## ORIGINATION FORM

Proposed Revisions to a Standard Plans Index  
(Please provide all information — Incomplete forms will be returned)

Index Number: 700-030  
Sheet Number (s): 1  
Index Title: Wind and Hanger Beams for Overhead Signs

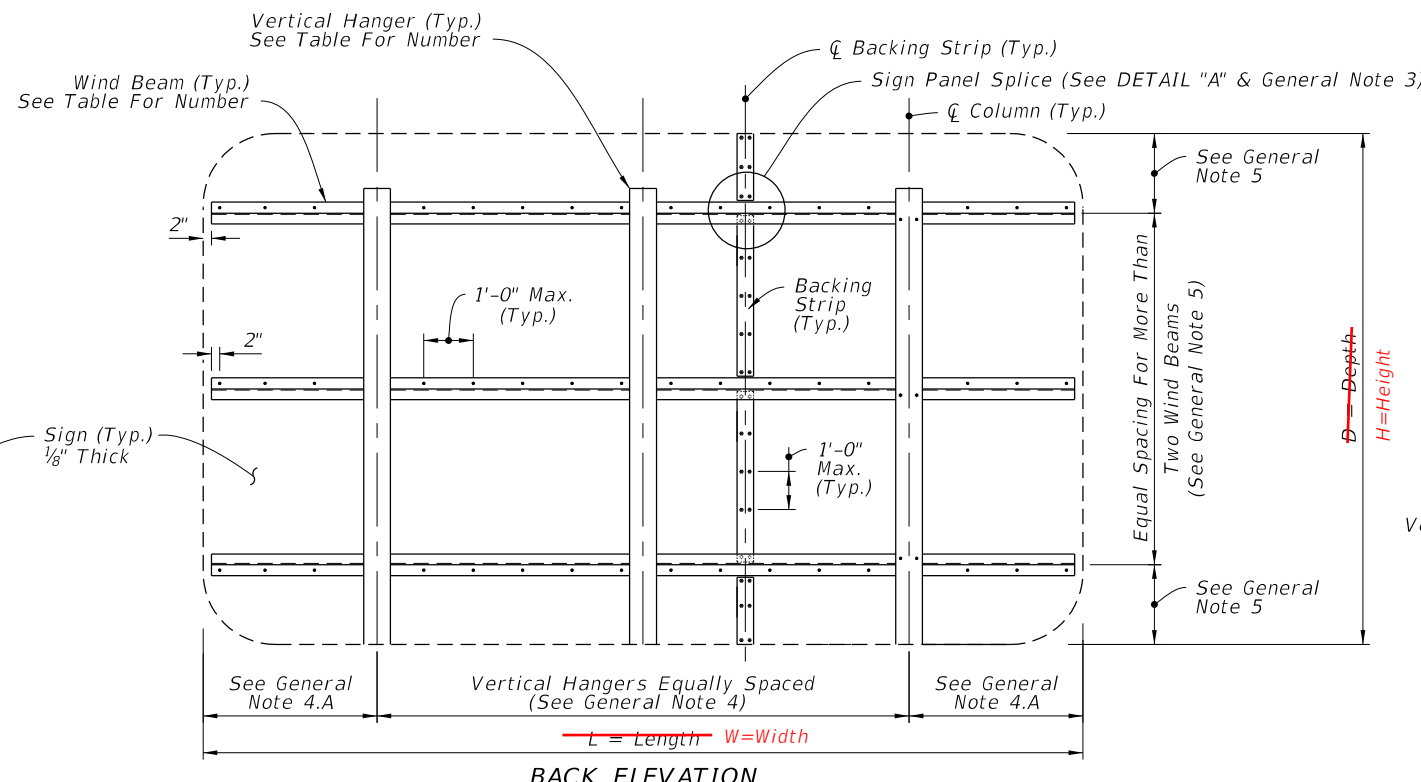
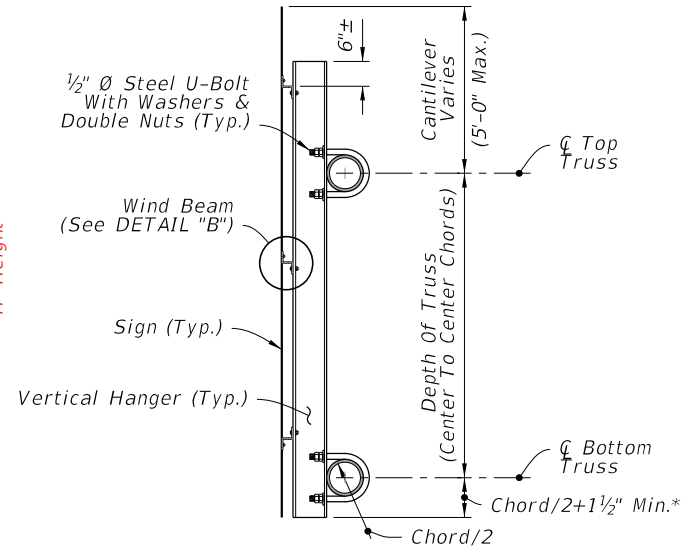
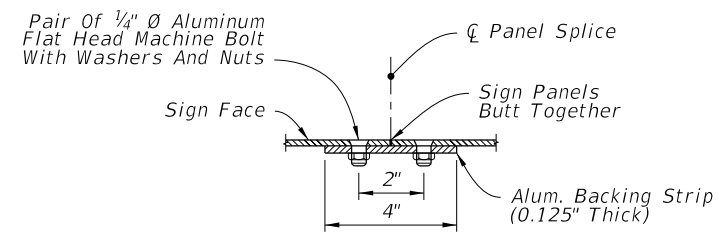
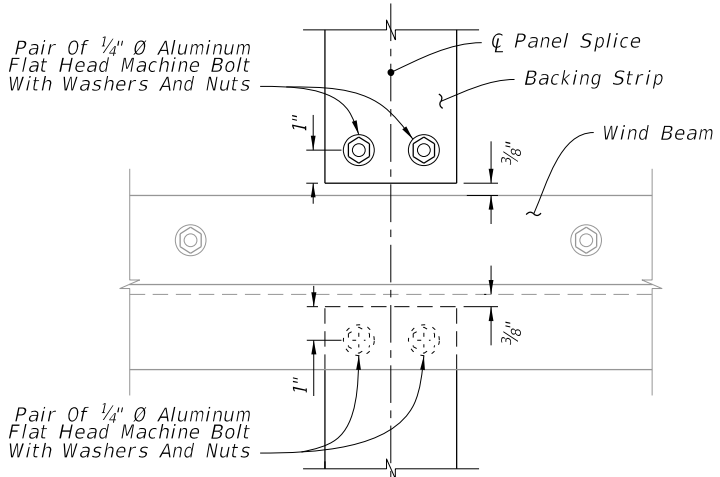
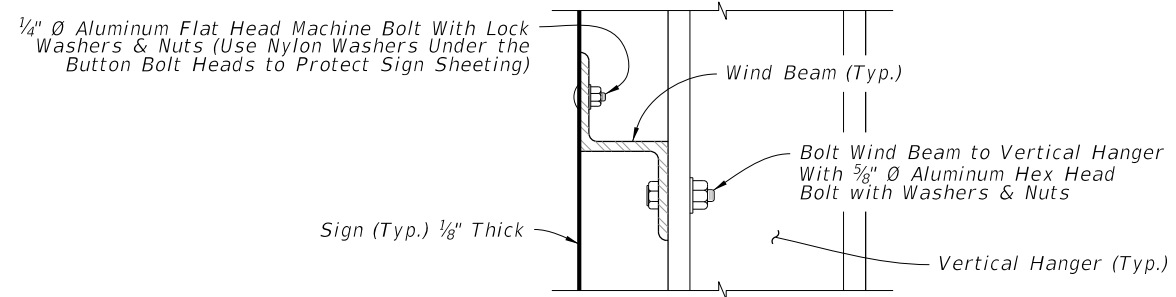
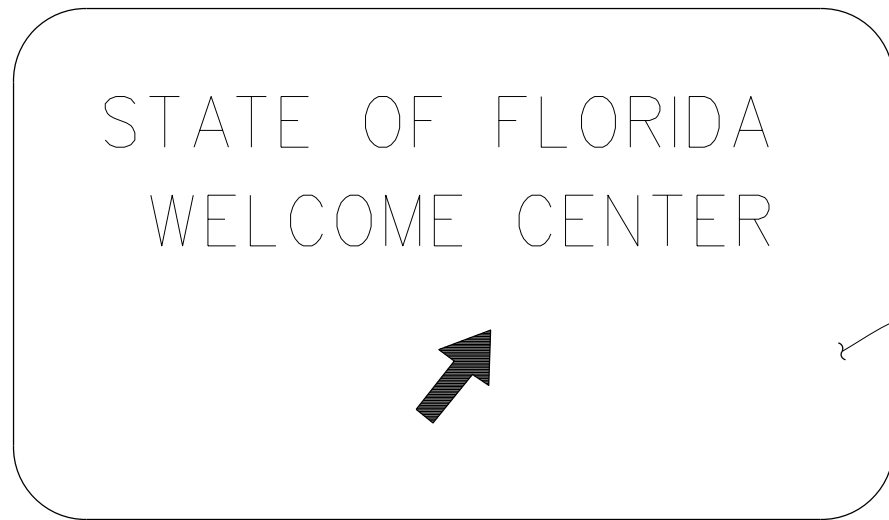
Changed all reference of length to width and all reference to depth to height.

The change is to be consistent with how the MUTCD dimensions signs. Section 700 and 995 will also need to be updated to be consistent with MUTCD.

CHANGED TO: Height (H)

CHANGED TO: Width (W)

Change to "W"
- Spacing of Wind Beams:
  - Two Wind Beams = 21.0% D
  - Three Wind Beams = 15.0% D
  - Four Wind Beams = 11.0% D
  - Five Wind Beams = 9.0% D
  - Six Wind Beams = 7.0% D

Change to "H"
- Shop Drawings:
  - A. Required for Sign Panels deeper than 10'-0" with a horizontal panel splice.
  - B. Splice must be located in between interior Zee Supports and only allowed on signs greater than 10'-0".
- Wind Speed by county: see Index 715-010.
